Company	Trenz Electronic GmbH
Number	AVN-20200319
Title	TE0807 system monitor reference voltage
Subject	System monitor reference voltage
Issue Date	2020-03-19

Products Affected

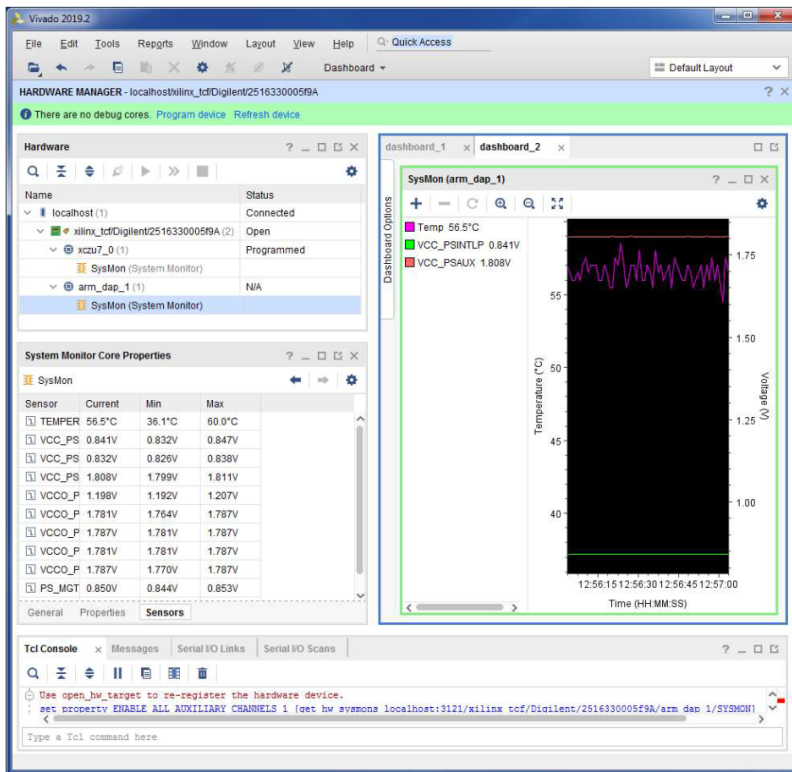
#1 System monitor ref. voltage input VREFP connected to 1.8V

Description: VREFP connected to 1.8V is out of recommended conditions. The PL XADC delivers values with non-standard scale factor.

Impact: It may cause an incorrect operation of SYSMONE4 and wrong internal sensor readings (VCCINT, VCCAUX, VCCBRAM, VCC_PSINTLP, VCC_PSINTFP, VCC_PSAUX and others). This will not cause damages on the module!

All PL XADC sensor values should be multiplied by 1.5 to get proper scaling in Volts.

Workaround: Either use scale factor 1.5 when using PL XADC or simple only use readings from PS XADC.
